NRC RAI 18:

WF3 Response 18:

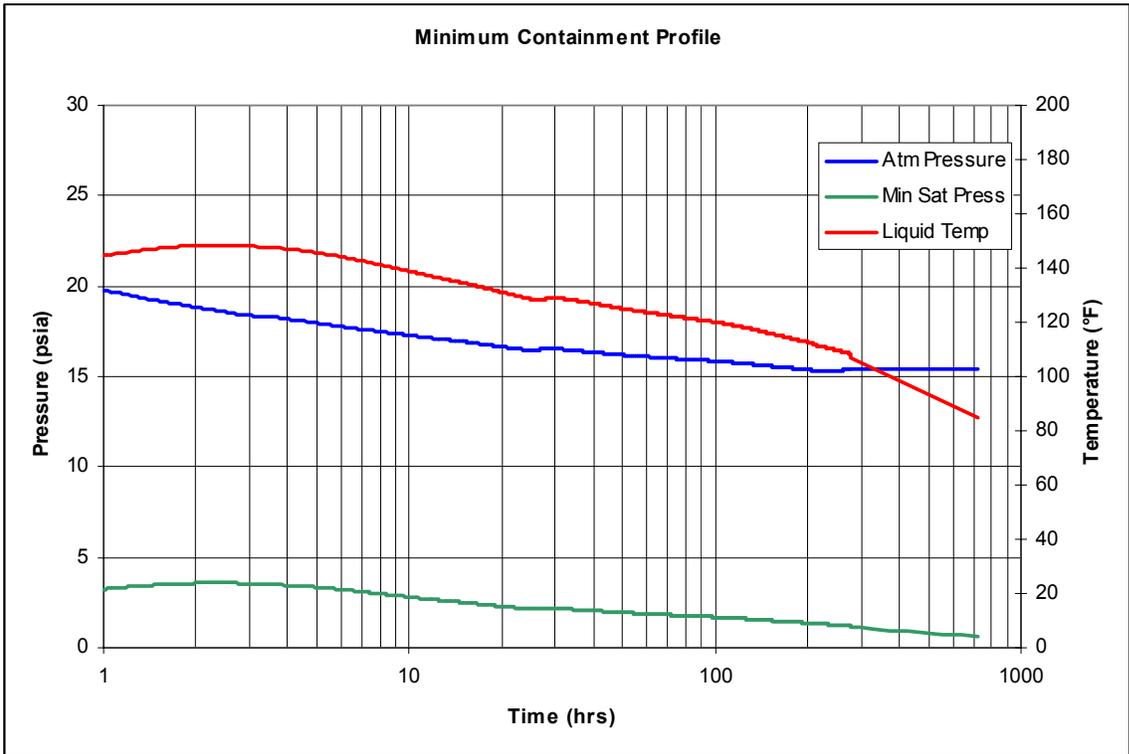
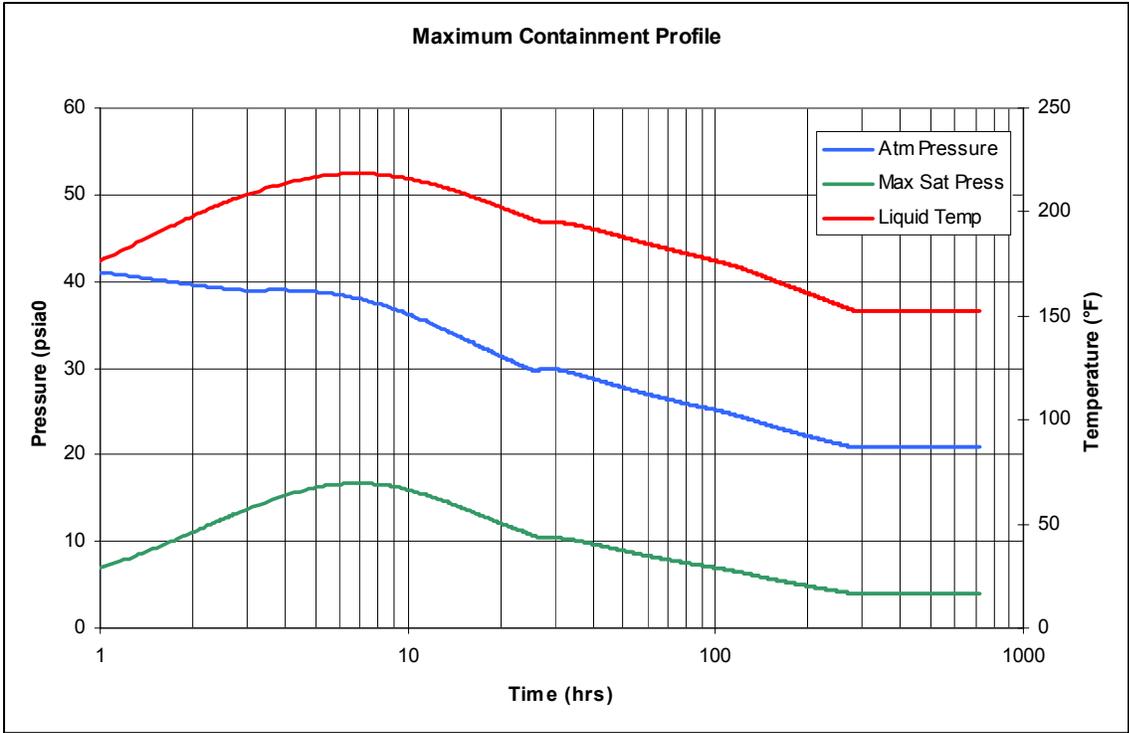
*The supplemental response dated October 23, 2008, stated that flashing at the strainer would not occur because the strainer submergence is 8 inches and the maximum head loss is about 6 inches. This is true for a large-break LOCA, but does not address a small-break LOCA, which has a bounding submergence of about 2 inches. Please provide an evaluation for flashing during a small-break LOCA at the most limiting condition. This may require an evaluation of head loss versus submergence over time or credit for accident-generated pressure.*

Credit for 1 psi of containment overpressure will provide > 2 ft flashing margin when submergence is less than the bounding head loss. Sump temperature will exceed 210 degrees Fahrenheit for only ~11 hrs during the event and the time to reach 210 degrees post Recirculation Actuation Signal is ~2.2 hrs. The maximum temperature profile is based on; (1) 1 of 2 Containment Spray Trains operating, (2) 1 of 4 Containment Fan Coolers operating, and (3) minimum Safety Injection flow. Waterford 3 Technical Specifications require containment pressure to be maintained between 14.275 psia and about 1 psig (27 inches water).

When expected containment pressure is compared to the saturation pressure of the sump fluid throughout the duration of an event it can be seen that adequate margin exists to support the 1 psi overpressure credit. Two cases are presented below. The first graph shows the comparison for the maximum sump temperature evaluation. The second shows the comparison for the minimum sump temperature evaluation.
